SUBJECT: REPLY TO A NOTICE OF NONCONFORMANCE - 99901350/2003-201

IE09

**Item 99901350/2003-201-01**

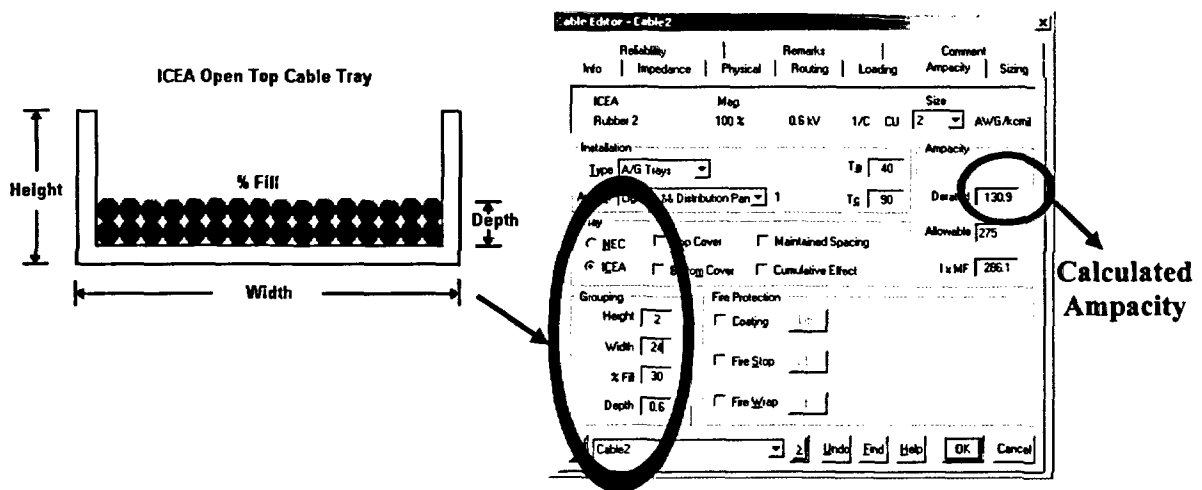
**NRC:** "As of January 8, 2003, OTI failed to ensure that its ETAP-PS library base Ampacity values for "free air" licensee applications was the same as that specified in the Insulated Cable Engineers Association (ICEA) Standard P-46-426 for free air values."

The NRC inspectors identified certain ETAP library Base Ampacities for free air that might have discrepancies with the corresponding data in ICEA P-46-426. These cable samples are shown in tables 1-3. These tables show comparisons of Base Ampacities for both "magnetic" and "non-magnetic" applications for 1/C & 3/C, 600 Volt cables.

**OTI:** The ICEA cable Base Ampacity values for "free air" applications were re-evaluated against the data provided in the Insulated Cable Engineers Association ICEA P-46-426. This re-evaluation has confirmed that ETAP library data based on ICEA P-46-426 is correct and no-errors were found.

ICEA P-46-426 only extends to free air Base Ampacities for non-magnetically installed cables. Therefore, if the free air Base Ampacities are to be compared against the ETAP library values, then the non-magnetic library subdivision must be selected. The Etap library shows the more conservative conduit in free air Base Ampacities for magnetic installations (trays that provide circulating currents).

- \* Not Available, ICEA P-46-426 does not provide Base Ampacity values for magnetically installed cables in free air (cable trays).
- \*\* ETAP library provides the conduit in free air Ampacities for cables with magnetic installation. ETAP considers cable raceways in free air (such as cable trays) that allow circulating current around the cable, to have the same Base Ampacities as that in conduit in air. Magnetically installed cables imply that there is a continuous raceway (conduit) around the cables with circulating current due to the magnetic field of the cables. This circulating current will prevent heat flow as well as generate heat due to  $I^2R$  losses. This is part of the reason why ETAP uses the more conservative (conduit in free air) Base Ampacity values for magnetically installed cables in cable trays.

- \*\*\* The ICEA P-46-426 conduit in free air Base Ampacities for triplexed cables are utilized for this application. 1/C cables (low voltage) cannot be placed in isolated trays. If 1/C cables are placed in a tray, ETAP considers all 3-phases are placed in the same tray, and utilizes the worst-case condition, which consists of the three 1/C cables bundled together in a triplex configuration. This is the reason why ETAP utilizes the ICEA triplexed cable Base Ampacities for this application, which is 130 Amps.
